UNITED STATES OF AMERICA
NUCLEAR REGULATORY COMMISSION

Application of SOUTHERN CALIFORNIA)	
EDISON COMPANY, <u>ET AL.</u> for a Class 103)	Docket No. 50-361
License to Acquire, Possess, and Use)	
a Utilization Facility as Part of)	Amendment Application
Unit No. 2 of the San Onofre Nuclear)	No. 89
Generating Station)

DESCRIPTION AND SAFETY ANALYSIS
PROPOSED CHANGE NPF-10-313

This is a request to revise Technical Specification 3/4.7.6, "Snubbers".

FIGURE NO. 1PLAN OR ELEVATION VIEW

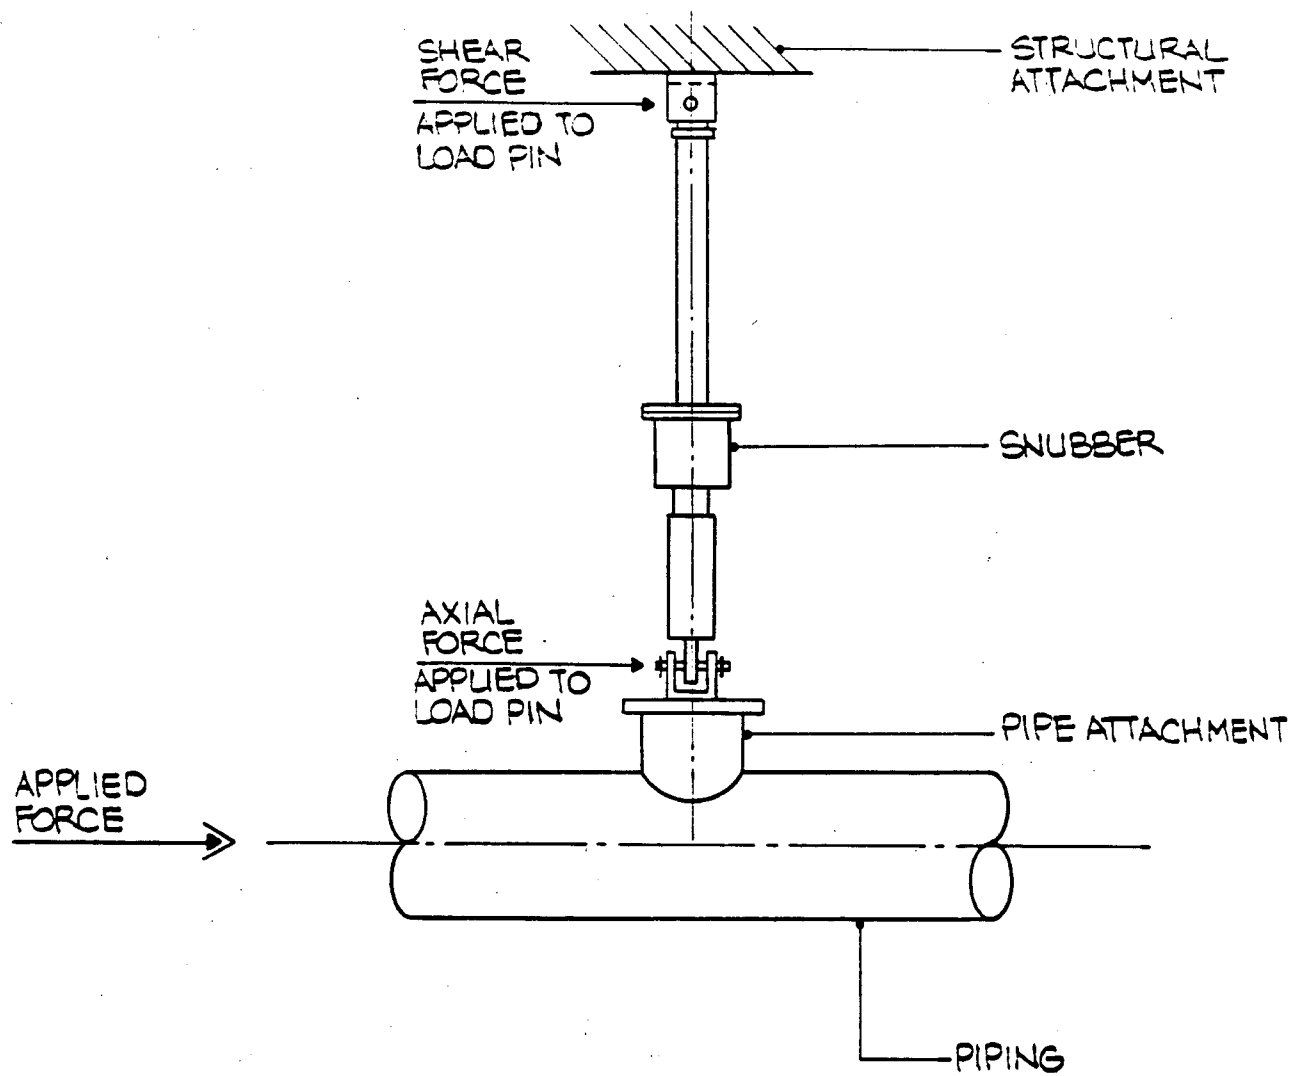
The two PSA 1 snubber visual inspection failures are the only occurrences of failure of a type 2 snubber due to snap ring detachment at SONGS. The snap rings on the PSA 1 snubbers are larger and heavier than those on the type 1 snubbers, and have not historically been prone to detachment. Additional root cause investigation found that both snubbers are in essentially identical configurations: installed on High Pressure Safety Injection System lines such that the load pins on one of their brackets are parallel to the pipe (see Figure 1), and located near a Safety Injection System containment isolation check valve. Leak testing of these check valves is required as part of plant start up after an outage. During the testing, pressure waves in the lines are sometimes experienced as a result of the valves slamming shut. The configuration of these snubbers is such that the resultant pipe movement from the check valve slamming shut, in conjunction with the generally high vibration environment for the two snub-

bers, could be sufficient to dislodge a snap ring on the load pin that is parallel to the pipe.

In order to ensure that PSA 1 snubbers that could potentially be subject to similar conditions were corrected, the snap ring type load pins on all PSA 1 snubbers on SI lines in Containment (not just those in the above configuration) have been replaced with cotter pin secured load pins. In addition, PSA 1 snubbers have been added to the snap ring replacement program. There are 26 remaining inaccessible PSA 1 snubbers with snap ring type load pins. These load pins will be replaced with cotter pin load pins in the first outage of sufficient duration, but in any case prior to end of the Cycle 6 refueling outage.
